**Economic and Social Council**Distr.: General
1 March 2023

World Forum for Harmonization of Vehicle Regulations**Working Party on Passive Safety****Seventy-third session**

Regulation No. 100 (Electric power trained vehicles)**Proposal for the 04 Series of Amendments to
Regulation No. 100 (Electric power trained vehicles) *****Submitted by the expert from the Netherlands**

Provisions for a Label for Vehicles of Categories M₂/N₂ and M₃/N₃ Equipped with an Electric Power Train

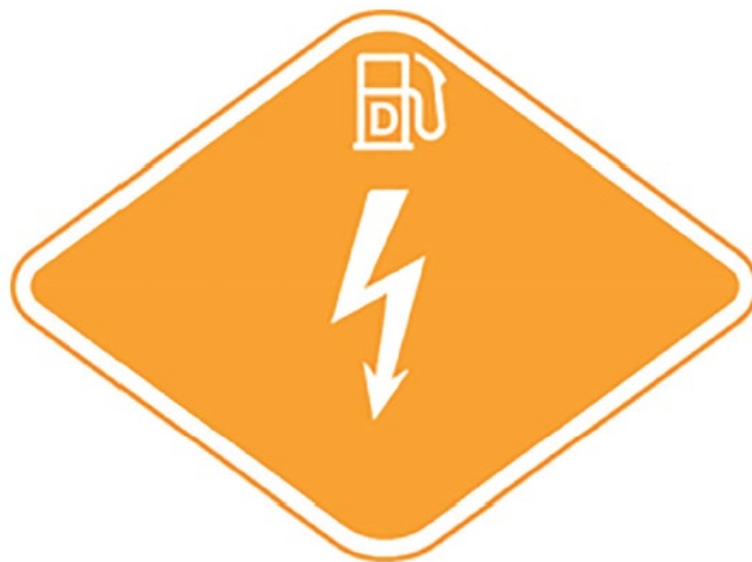
Introduce a new Annex 10, to read:

The label consists of a sticker which shall be weather resistant.

The centre zone indicates the first energy source.

The upper zone indicates the second energy source.

Layout and symbols shall be in accordance with ISO 17840-4:2018.

The colour and dimensions of the sticker shall fulfil the following requirements:

Background:	Orange, RGB code 255, 165, 0
Border:	white or white reflecting
Letters:	white or white reflecting

Sticker width:	110 – 150 mm
Sticker height:	80 – 110 mm"
